Re: Sunrise Project Modification 7 – Request for Information (EPA Advice on Submissions Report)

Response to Air Quality-related Matters in the EPA Advice on the Submissions Report

Sunrise Project - Project Execution Plan Modification - Response to Noise-related Matters in the EPA Advice on the Submissions Report

ATTACHMENT 1 Modelled ground-level concentrations

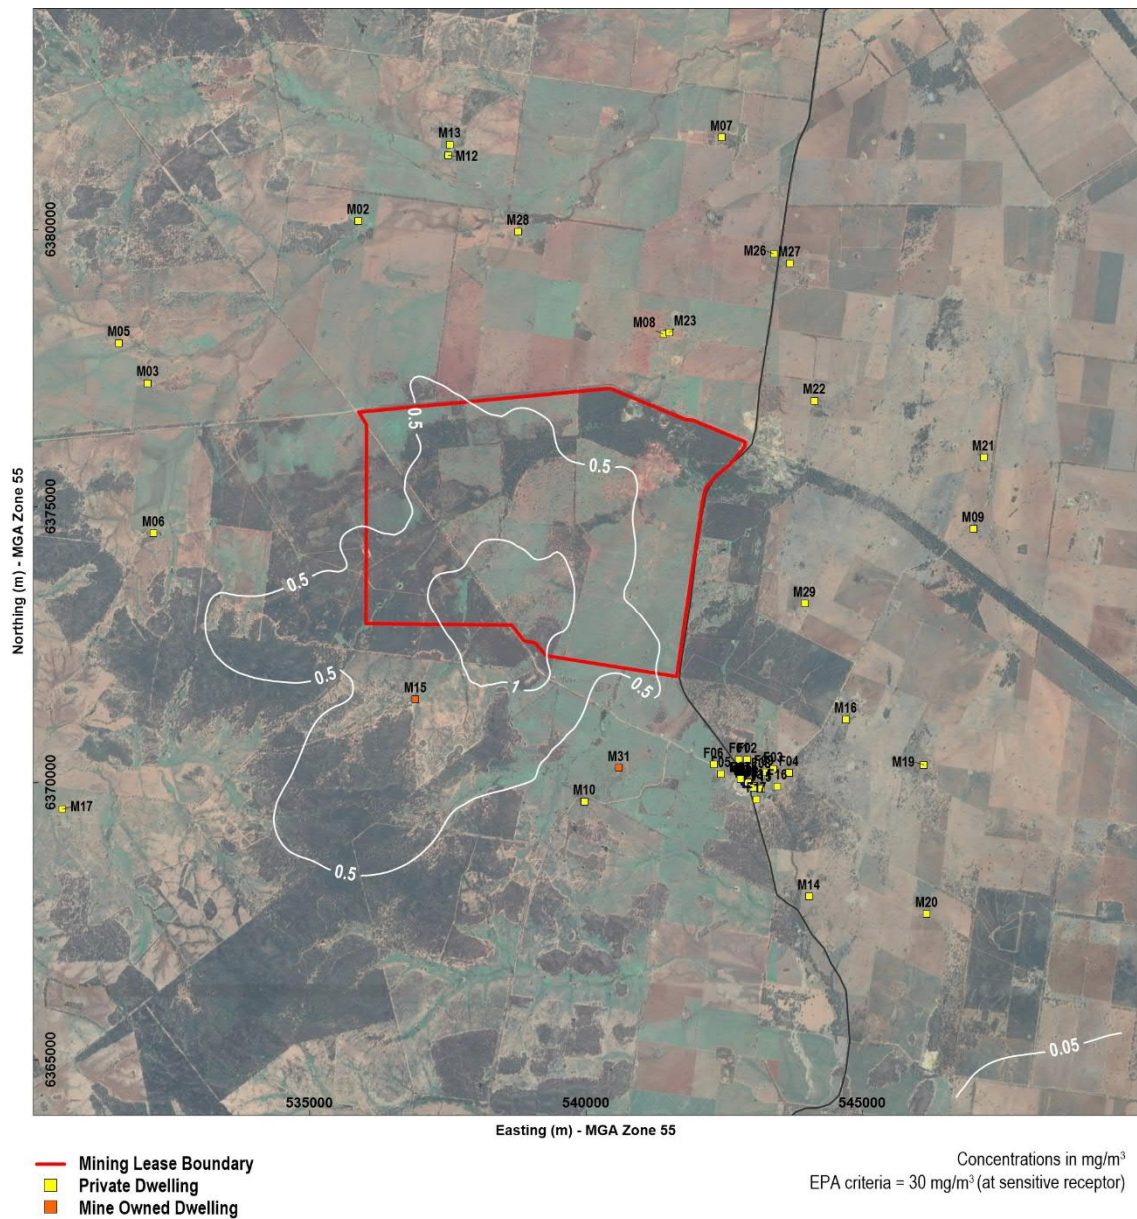
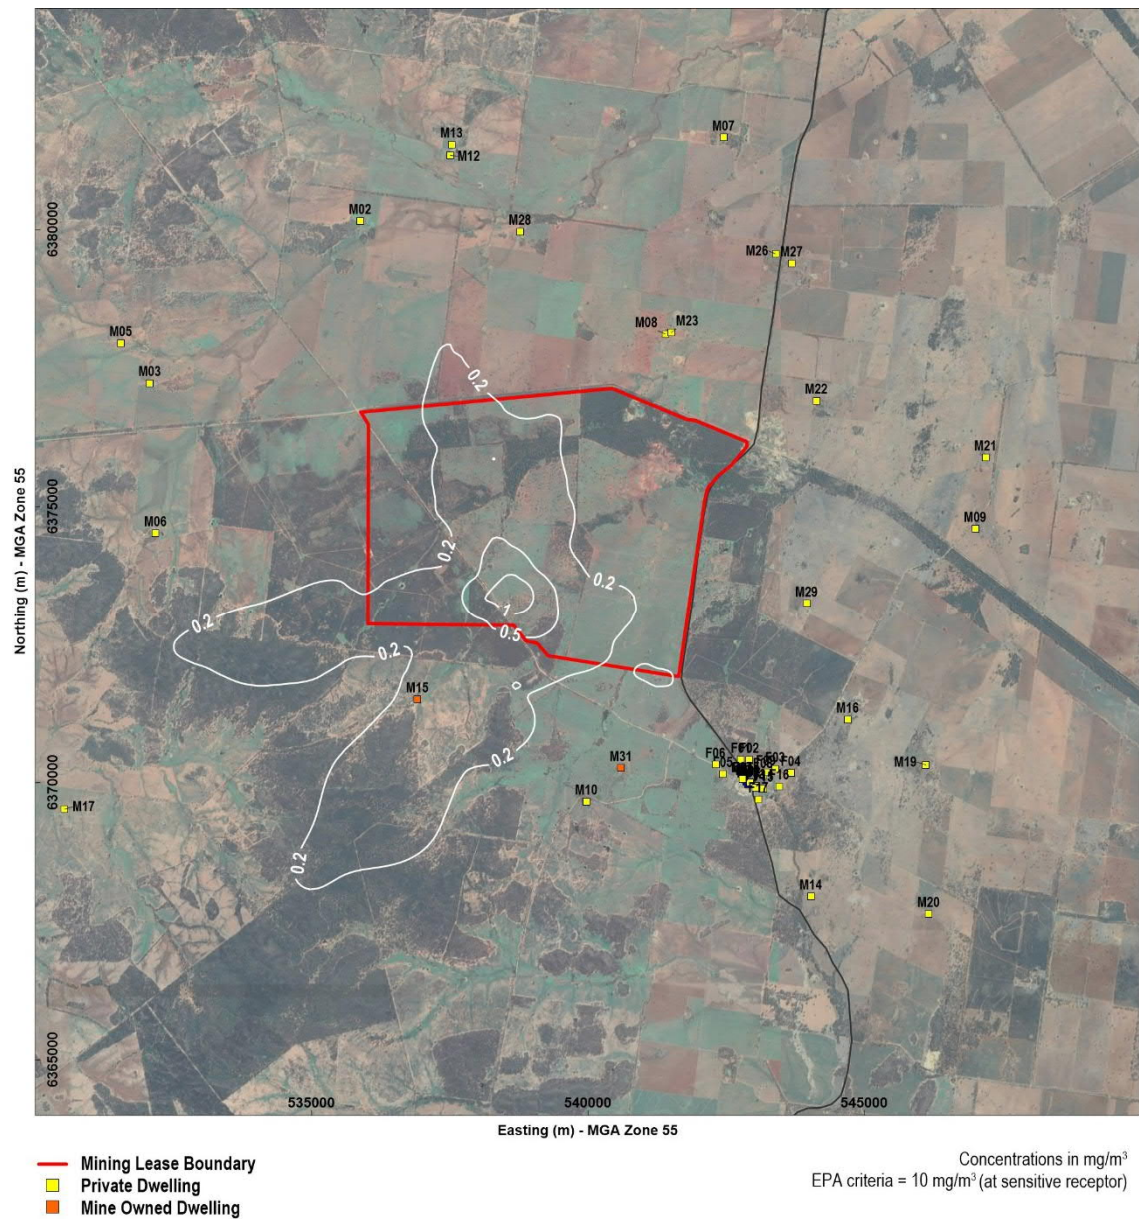
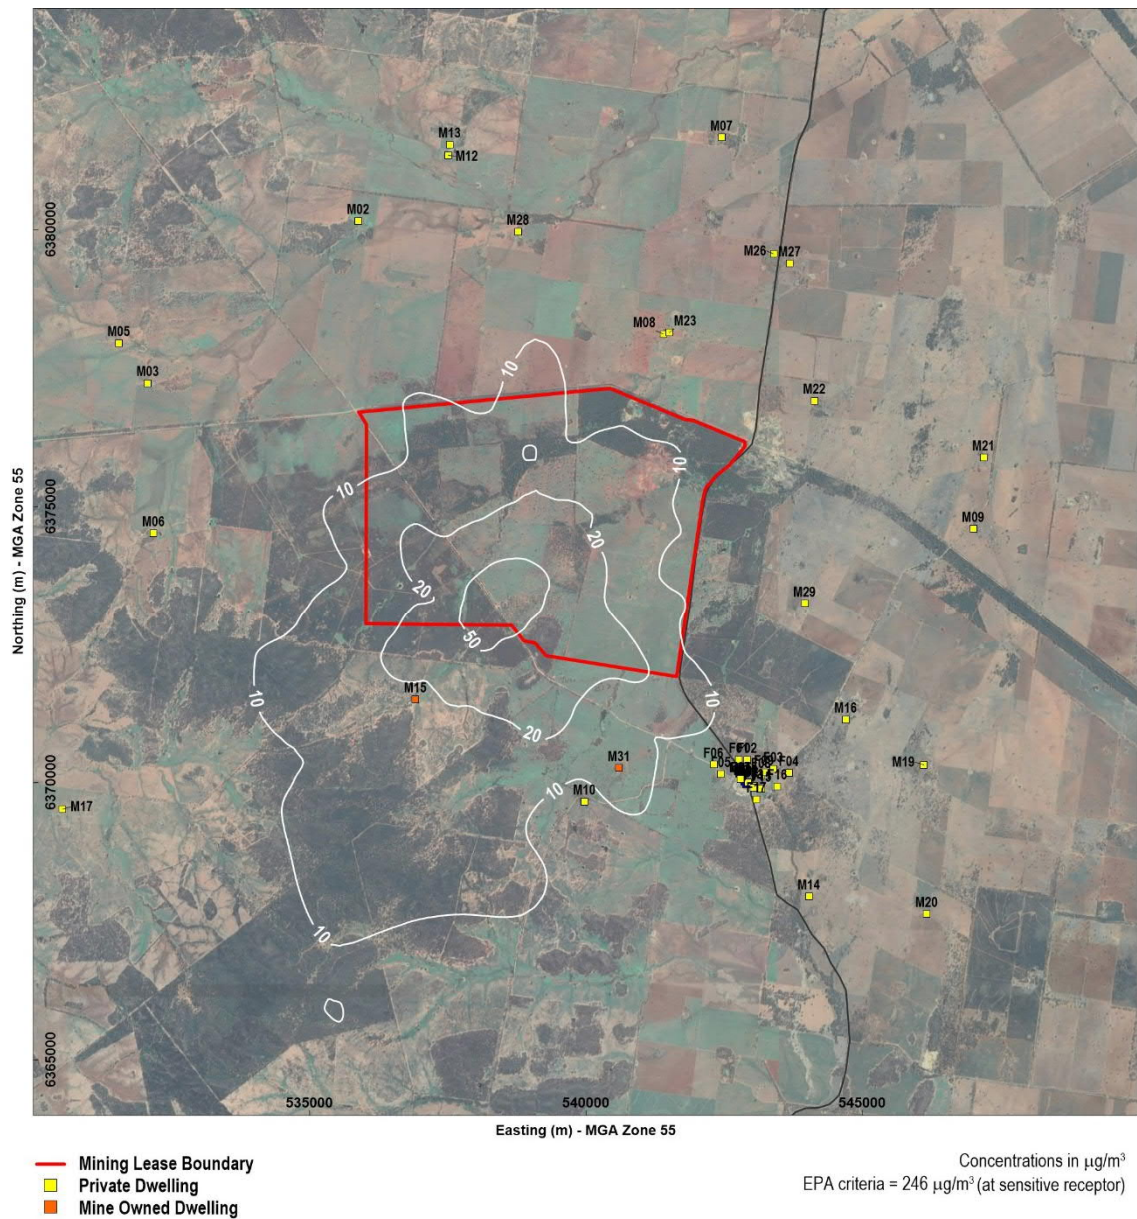
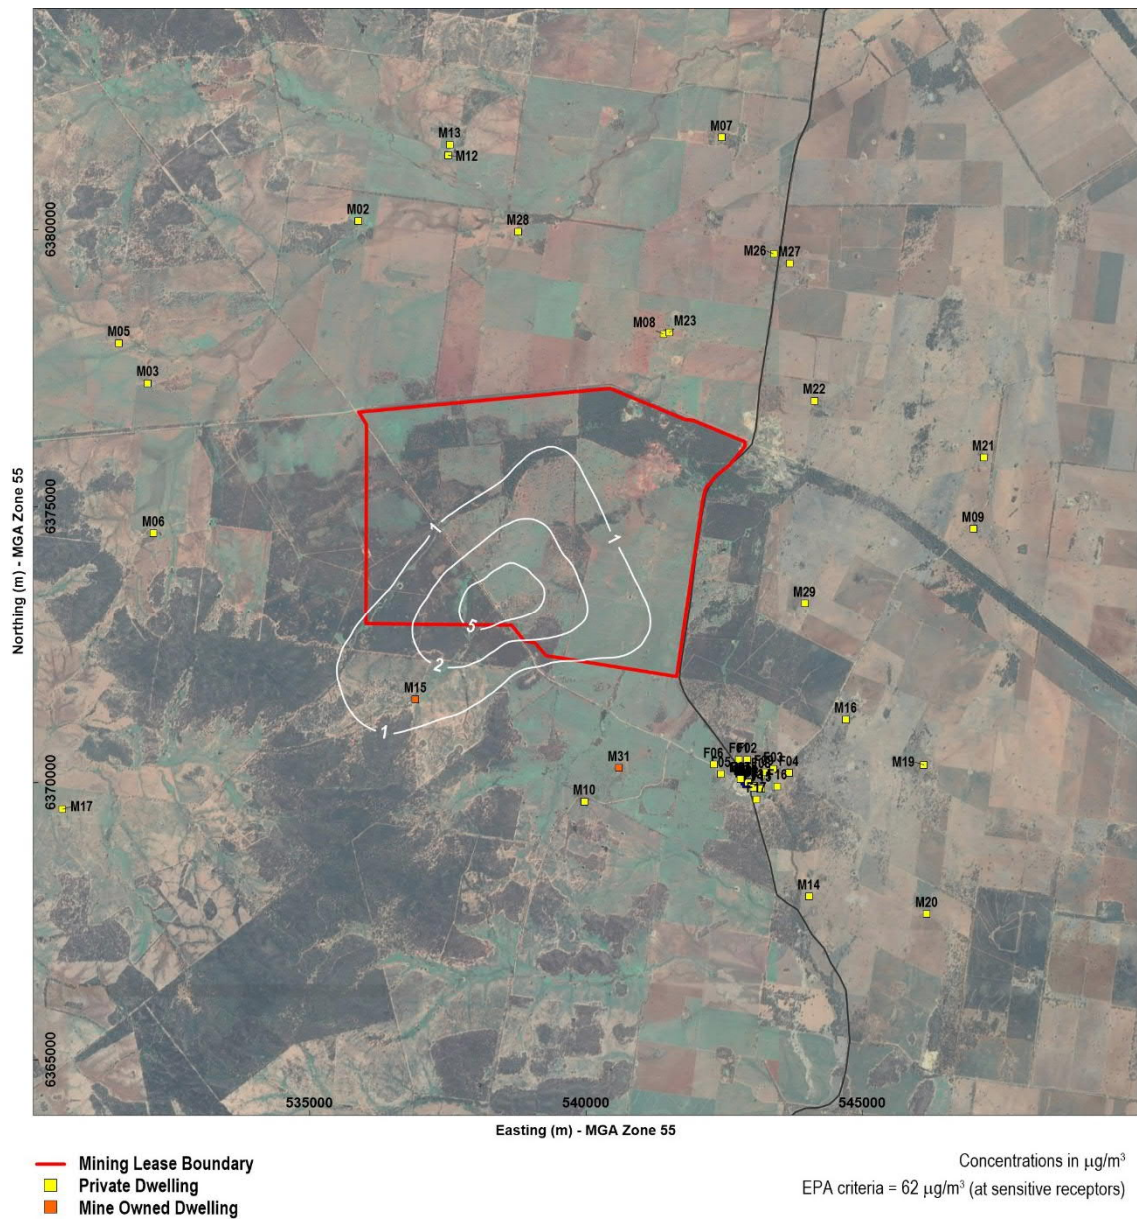
- 2) Demonstrate that the speciated VOCs assessed have the greatest potential for ground level impacts. The EPA recommends additional analysis comparing the magnitude of speciated VOCs with relevant impact assessment criteria to demonstrate the speciated VOCs assessed are representative of worst-case emissions and potential impacts.
- 3) Revise the Air Quality Impact Assessment to ensure that emissions and potential impacts are based on reasonable worst-case emissions. This includes:
 - i. an assessment of the potential impacts of additional VOCs identified through the additional analysis described above.
 - ii. consideration of plant specific emission performances.

- Maximum 1-hour average CO concentrations do not exceed the air quality assessment criterion (30 mg/m³) at the nearest sensitive receptors.

- Maximum 8-hour average CO concentrations do not exceed the air quality assessment criterion (10 mg/m³) at the nearest sensitive receptors.
- Maximum 1-hour average NO₂ concentrations do not exceed the air quality assessment criterion (246 µg/m³) at the nearest sensitive receptors.
- Annual average NO₂ concentrations do not exceed the air quality assessment criterion (62 µg/m³) at the nearest sensitive receptors.
